August 23, 2023

RE: Supplemental Memorandum
Related to Letter of Intent for Club Car Wash
3909 and 3913 Lien Road

CLUB CAR WASH - MADISON, WI | 08.23.23

FIRST FLOOR NORTH ELEVATION

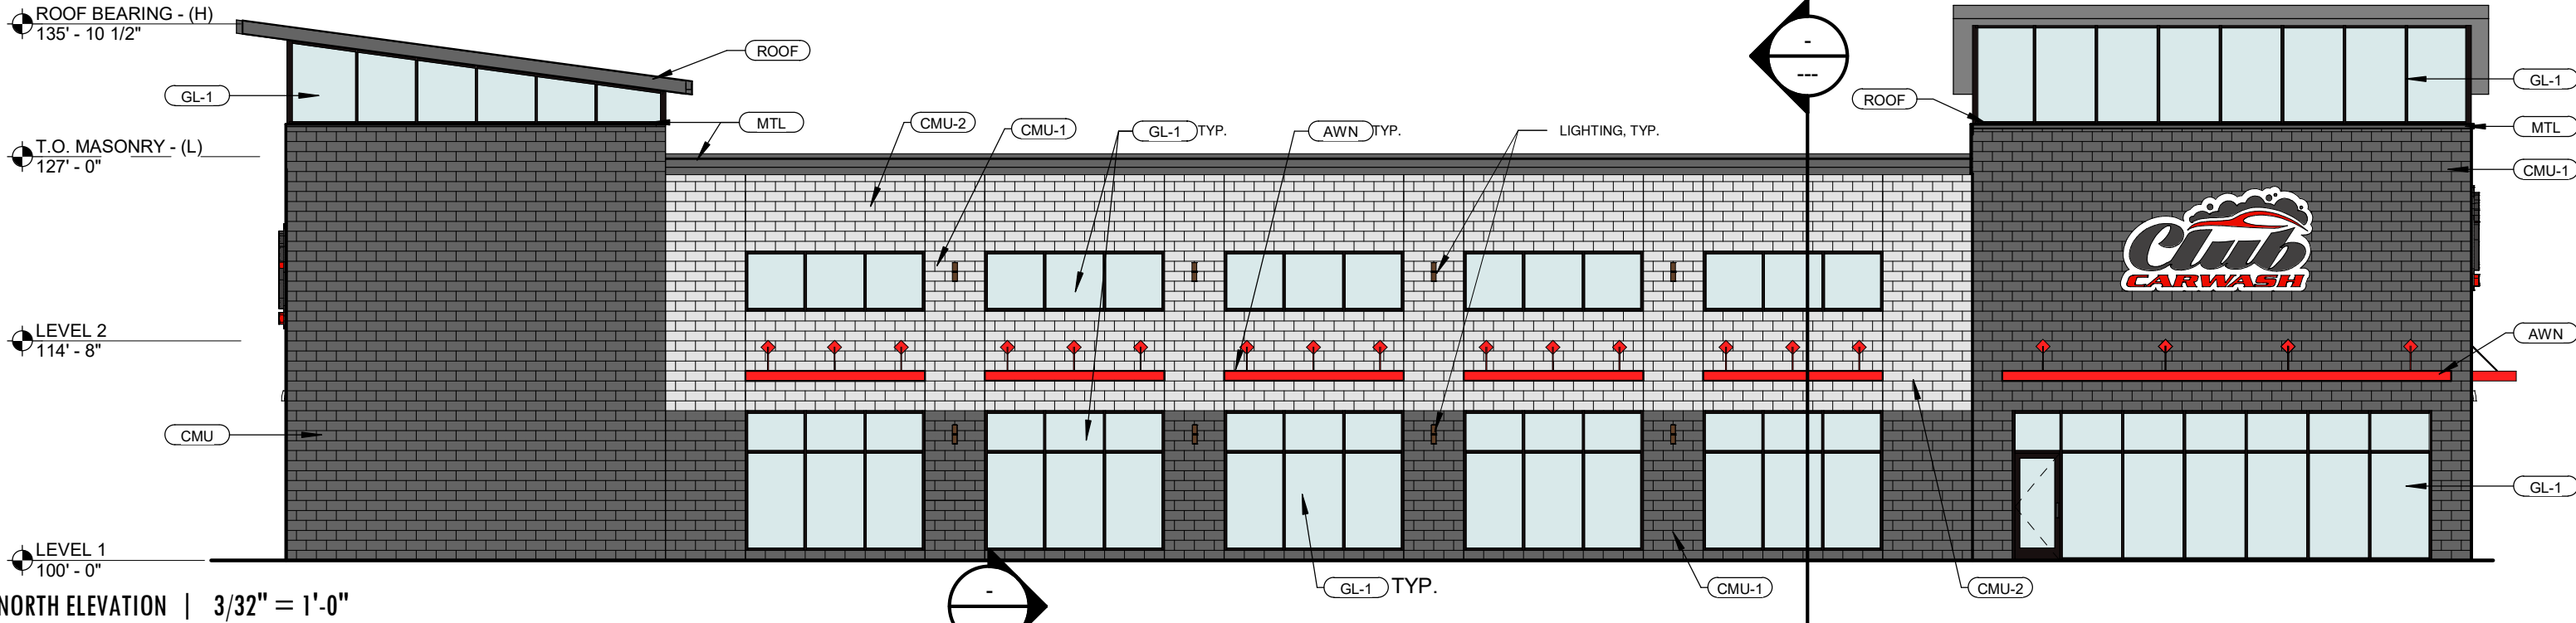
B. With respect to the building design, Applicant received comments from the Urban Design Commission as well as from City staff, including comments on building materials as well as the placement of windows on the second floor of the building and the slope direction of the tower. Attached hereto in response to those comments please find updated supplemental elevations and an updated rendering reflecting changes as follows:

1. Raising the height of the second story windows.
2. Replacement of CMU with burnished block and change in location of burnished block on the building.
3. Replacement of EIFS with burnished block.
4. Rotation of the slope direction of the tower.
